## 0.0 Application for Review P1938/2019 of Planning Permit Application PLN18/0598 at 21 Glendale Avenue, Templestowe (Amended Plans for VCAT)

File Number:	IN20/56
Responsible Director:	Director City Planning and Community
Applicant:	Kamber Invest Pty Ltd
Planning Controls:	General Residential Zone, Schedule 2; Design and Development Overlay, Schedule 8-3 (Sub-Precinct B); Principal Public Transport Network (PPTN)
Ward:	Heide
Attachments:	<ol style="list-style-type: none"><li>1 Advertised Plans (Original Proposal)</li><li>2 Delegate Report (Original Proposal)</li><li>3 Refusal Notice (Original Proposal)</li><li>4 Amended Plans (New Proposal)</li><li>5 Legislative Requirements</li></ol>

Figure 1: First floor plans.

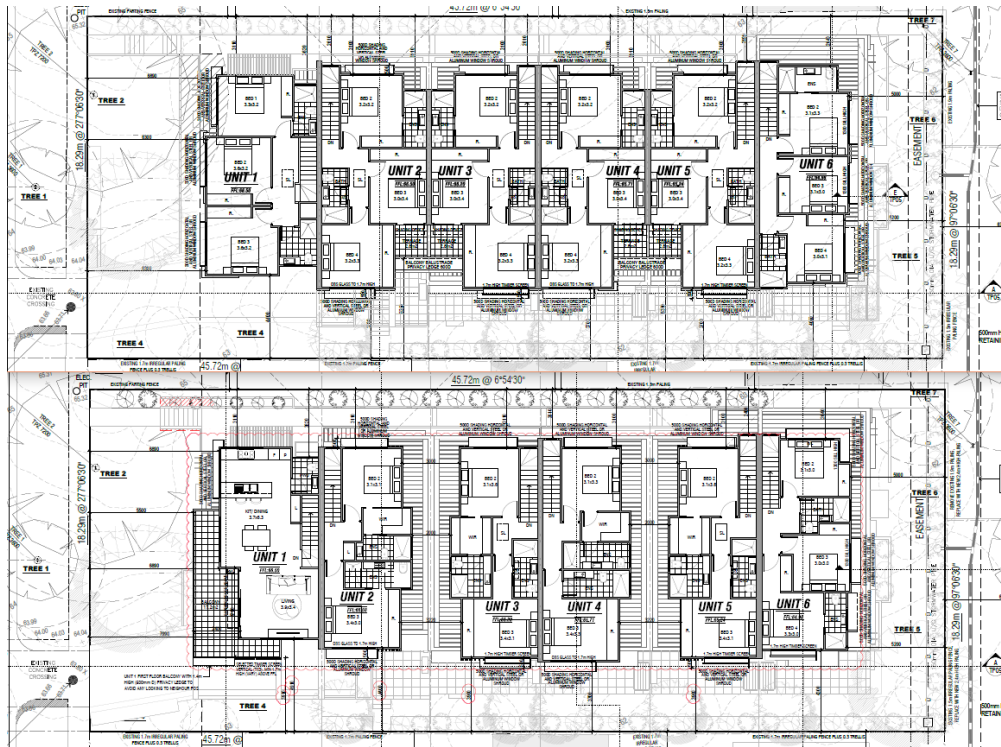
- 8.12 The Amended Plans significantly reduce the size of the first floor level, introducing two clear breaks between dwellings and increasing setbacks to the south. Further, the amended proposal has removed the heavy gable elements from the side and rear elevations. These changes serve to significantly reduce visual bulk at the upper level.

- 8.13 The following images provide a comparison of the Decision Plans (top) and Amended Plans (bottom), demonstrating the evident reduction in bulk:
